TRANS/WP.29/GRRF/57  
14 April 2005

Working Party on Brakes and Running Gear (GRRF)

**REPORT OF THE WORKING PARTY ON BRAKES AND RUNNING GEAR (GRRF)  
ON ITS FIFTY-SEVENTH SESSION**

Insert a new paragraph 3.1.12., to read:

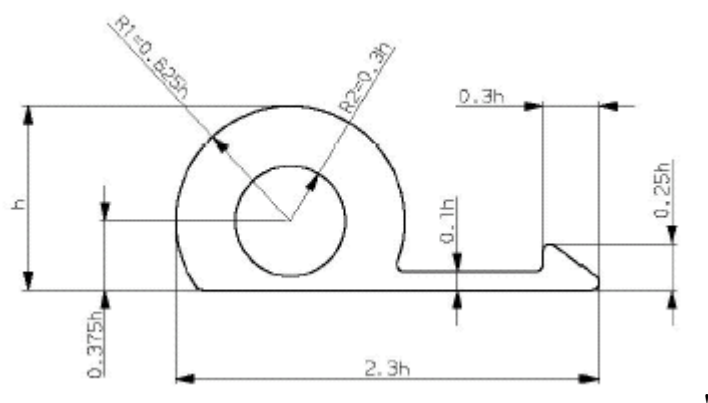
"3.1.12. The symbol below if the tyre is a "run flat" or "self supporting" tyre, where "h" is at least 12 mm.
